# ULVAC Components News

## Sales Termination

【Product model】 Pirani gauge sensor head WP-01, WP-02, WP-03, WP-16

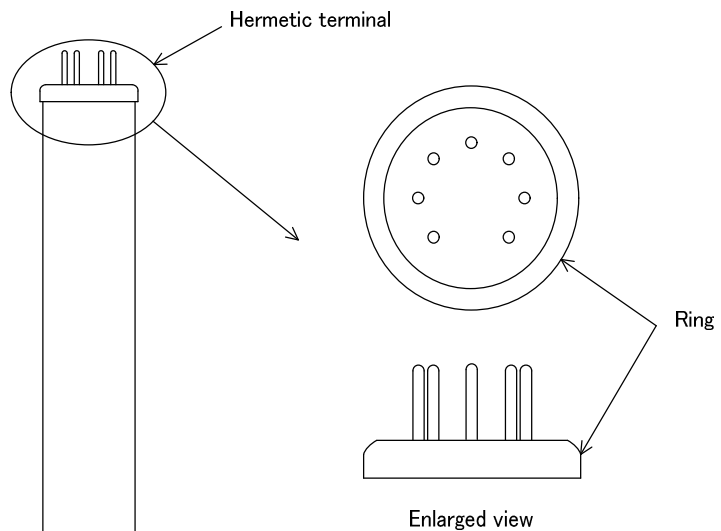
【Changes】Supplier and the ring of Hermetic terminal.

Before; FeNi alloy Ni plating finish

After; FeNiCo alloy Ni plating finish
